# memorandum

subject Qwuloolt Estuary Restoration Site
As-Constructed analysis City Review Draft

**Figure 1**

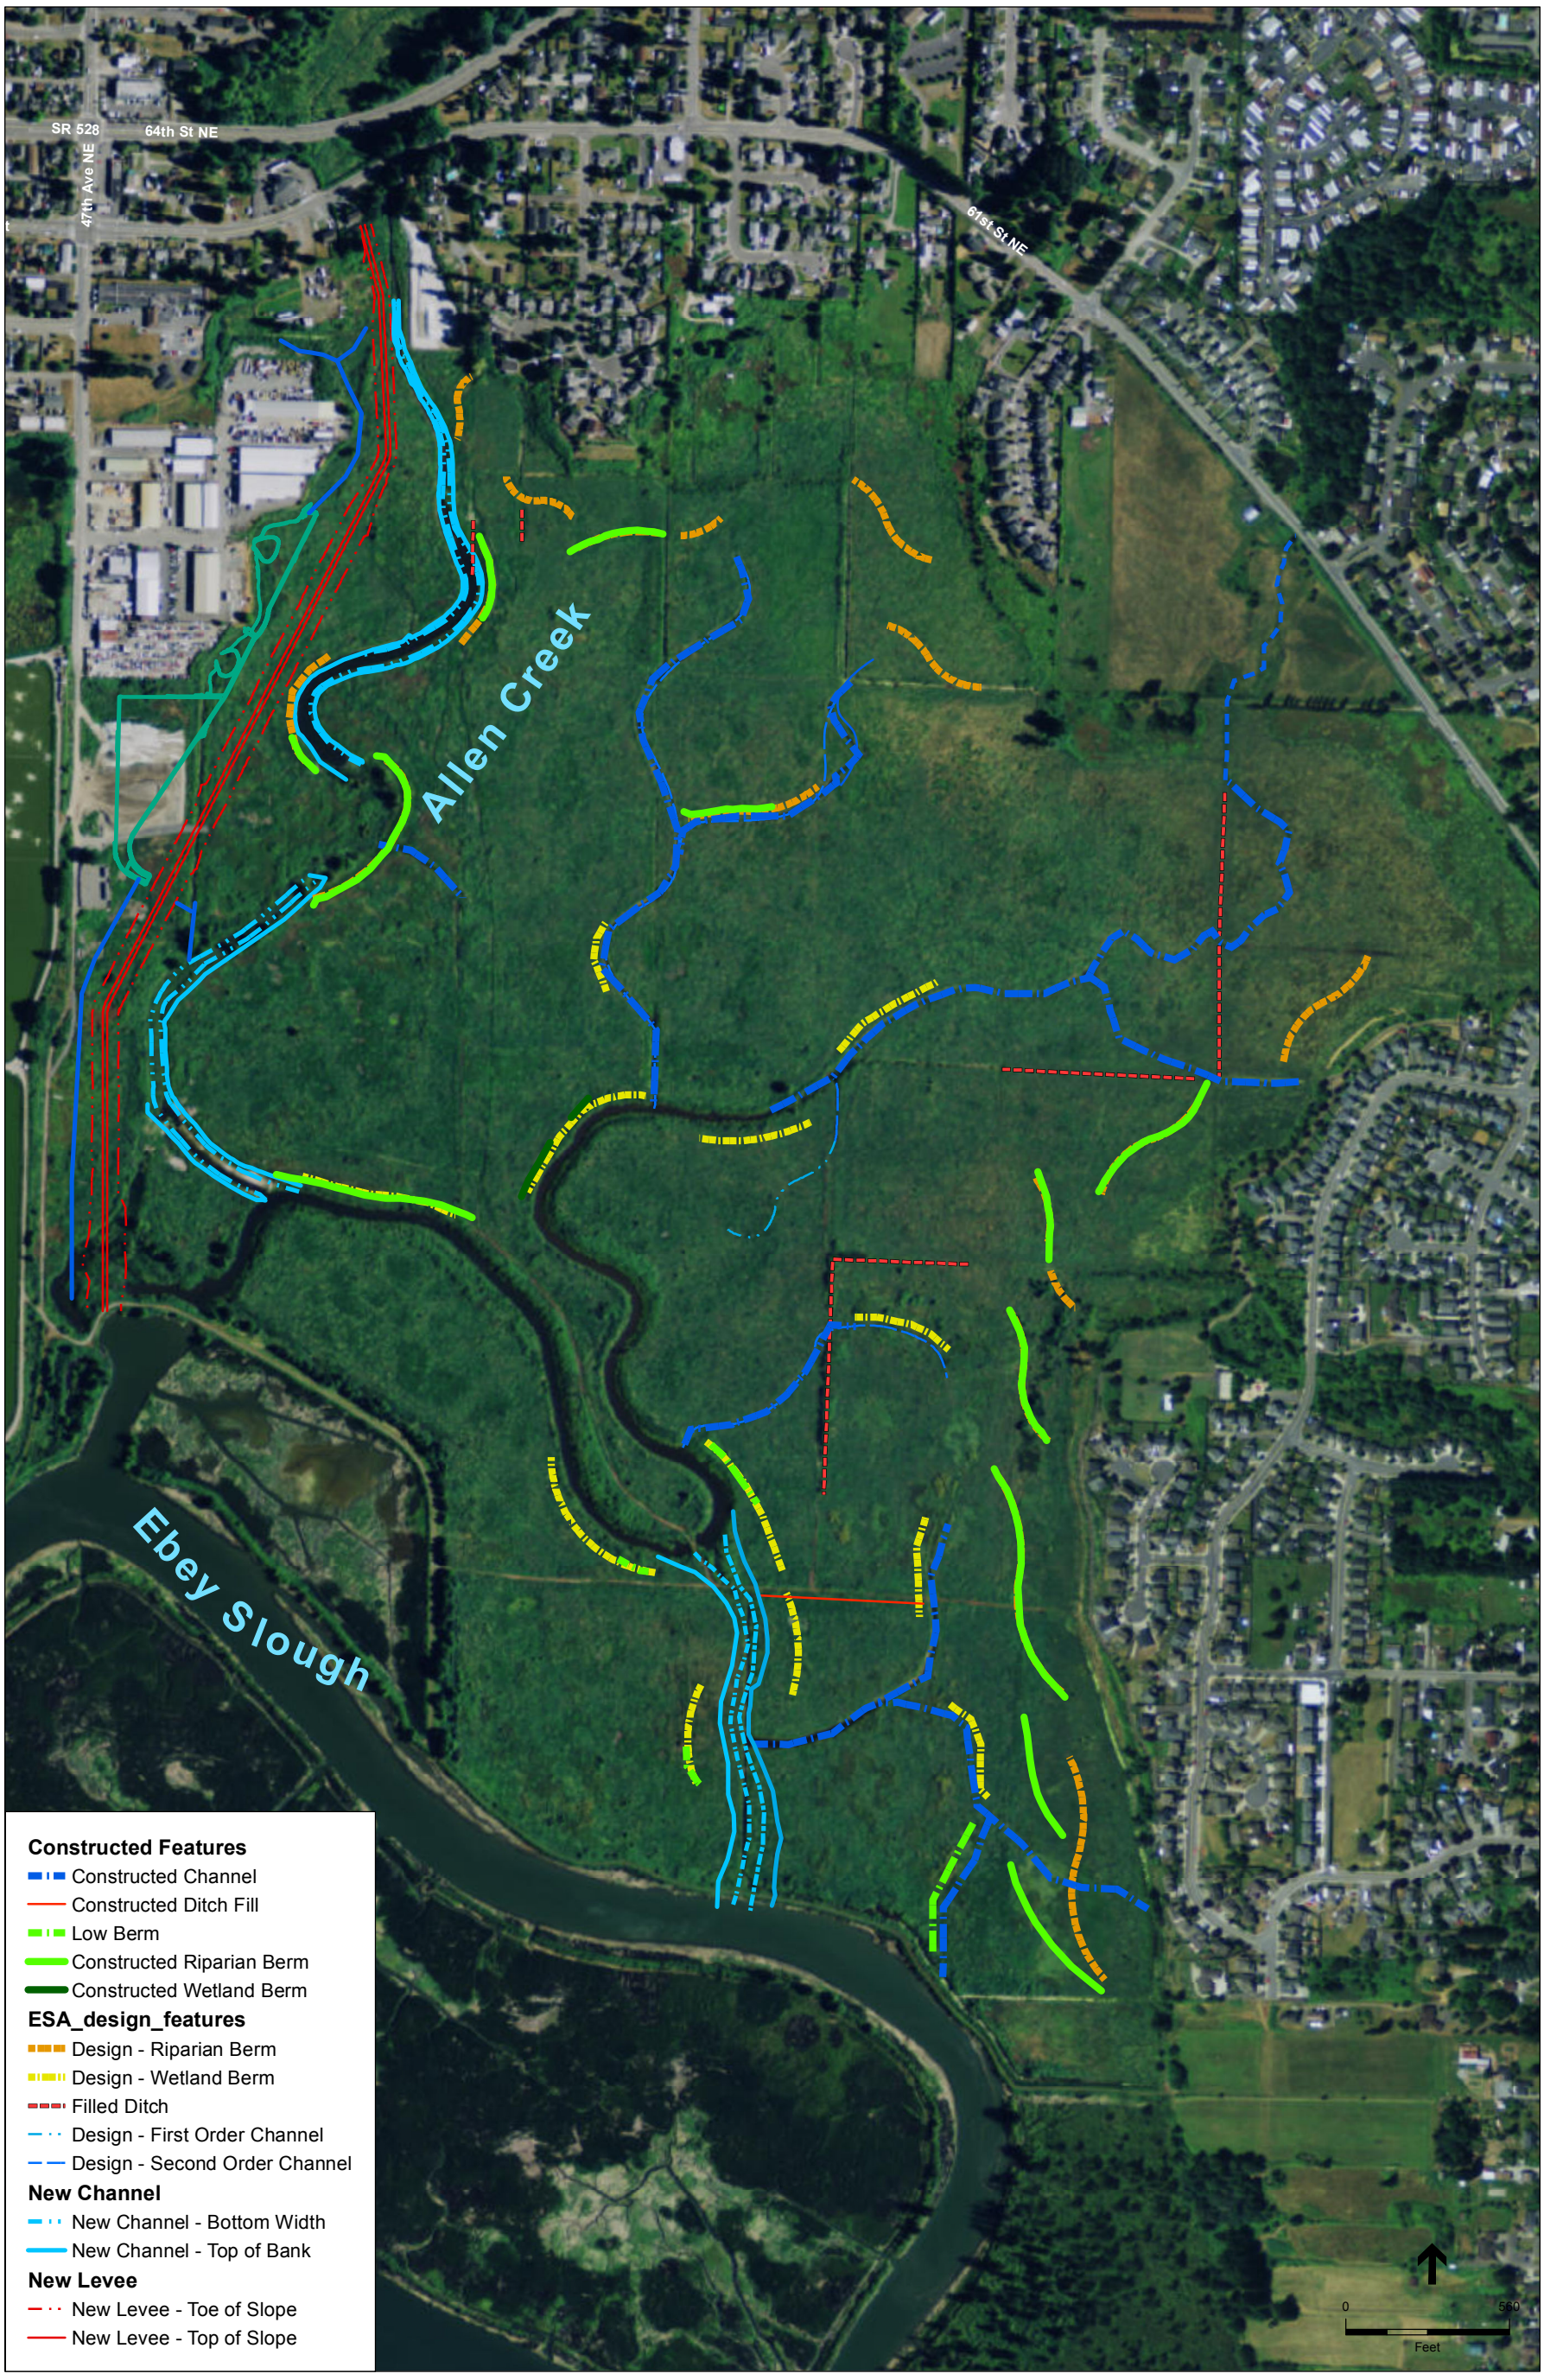
Currently, both creeks have been moved into their new meandering alignments. Many tributary channels have been excavated and appear to connect into appropriate drainage points around the perimeter of the site. Figure 1 depicts the layout of the excavated channels based on our observations and recent aerial photographs. We do not have detailed survey to show the actual as-built plan-form or cross-sections at this time.

2. Minor revisions were noted compared to the proposed drainage network, apparently to better connect into the perimeter ditches that were left intact.

Recommendation: No changes needed. Post-breach site drainage will include some linear drainage features, but drainage appears to be sufficiently linked to perimeter drainage points to achieve the goals of providing tidal flux throughout the site and not impeding drainage coming from off-site.

**Figure 2**
Recommendations
for Berm Construction

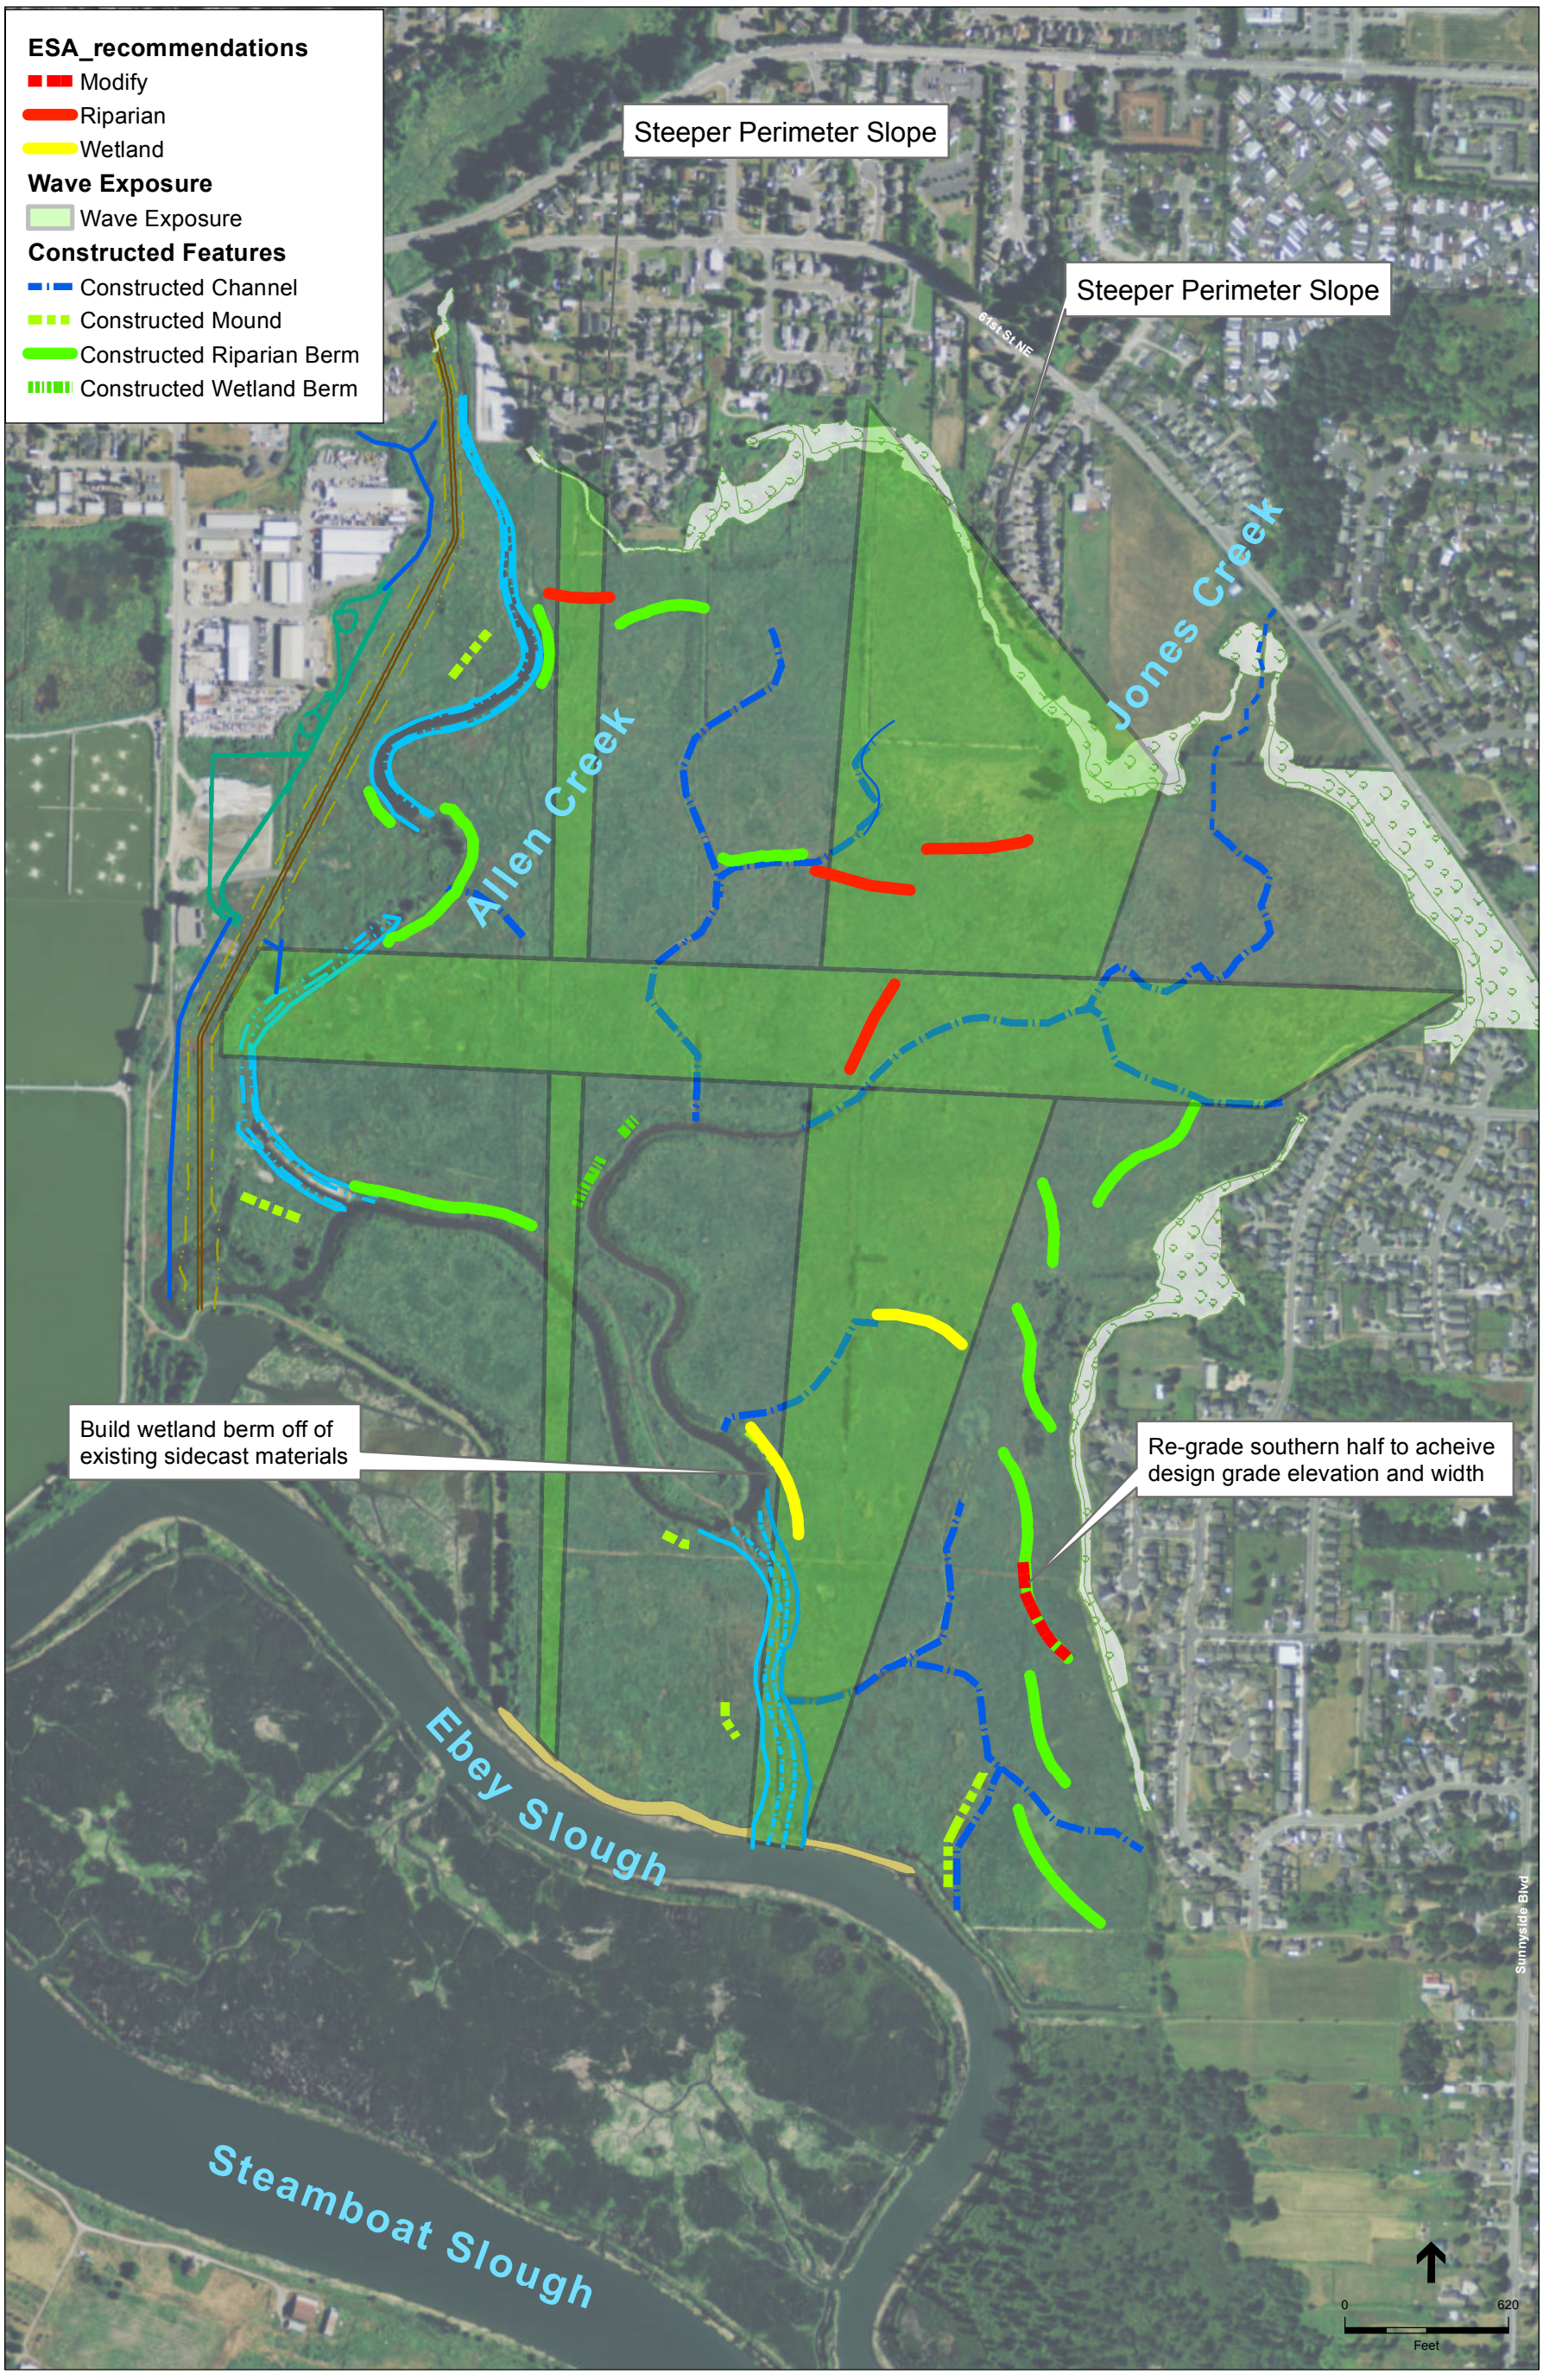
To depict how the number and locations of constructed berms may affect the wave attenuation function around the perimeter of the site, Figure 2 shows the constructed berms along with exposure gaps where berms are lacking. Figure 2 also shows where additional wave attenuation berms are still needed to provide protection to steeper portions of the site. It should be noted that the berms are not engineered structures, but rely on vegetation establishment to limit erosion and enhance wave dissipation. Also, the berms are not complete barriers to waves, which can propagate past the berms by diffraction and refraction around them, and waves will migrate over the top of the berms depending on the water depths and dissipation. Hence, the design also required perimeter planting, monitoring and adaptive management to provide additional protections if needed.

1. Observation: Fewer wave attenuation berms were constructed than designed.

Based on what has been constructed to date, project timing, material availability, site constraints and funding availability we recommend focusing on constructing the berms depicted in Figure 2 at a minimum. We understand that perimeter planting treatments are occurring and are ongoing which will limit erosion potential. Perimeter Monitoring will be required to ascertain whether wave action induces erosion around the perimeter of the site and if so remedial actions along the site perimeter may be required. We therefore expect that the impact of reduced berm construction can be mitigated by perimeter treatments when and where such treatments are needed.

Recommendation: We recommend that, if full berm installation is not feasible for the project, at least six additional berms be constructed in the locations depicted on Figure 2 to close the primary gaps. Four of the proposed berms would be riparian, and two would be wetland berms.

**Figure 3**

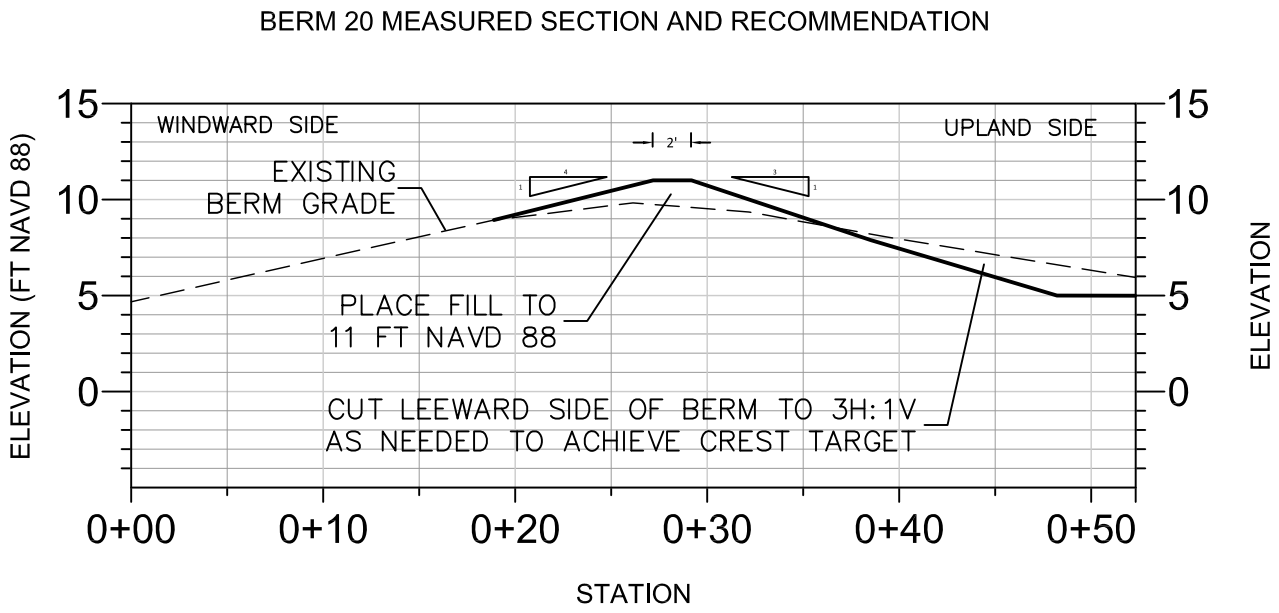
2. Observation: Some of the riparian wave attenuation berms have settled and are below the target elevation.

Recommendation: The riparian berms that we checked do exceed MHHW elevation, and will likely support plantings, so no modifications are proposed to the previously constructed berms, with one exception at the southern half of Berm 20. This location is in front of one of the steepest, most exposed sections of the perimeter shoreline.

This berm should be regraded to widen and increase the elevation of the crest while allowing a steeper the backslope (Figure 3).
